A66 Northern Trans-Pennine: Response to Procedural Decisions (Rule 9 Letter)

Annex 1: Response to matters arising from acceptance

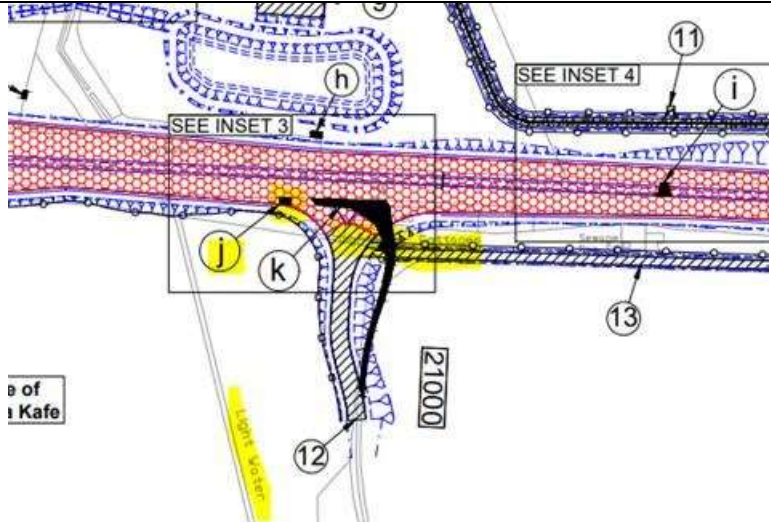
5.19	Rights of Way and Access Plans	<p>Scheme 03 Penrith to Temple Sowerby Draft DCO Schedule 2 Part 4 (page 177) refers to Reference J “Access to a garden at Lightwater Cottages.” Please check whether this should be shown on the plans as it is absent.</p>	<p>National Highways can confirm that Reference J is included on the submitted plans, an extract of the plan with highlight is included below. The extract also shows (highlighted) the reference to “Lightwater Cottages”.</p>
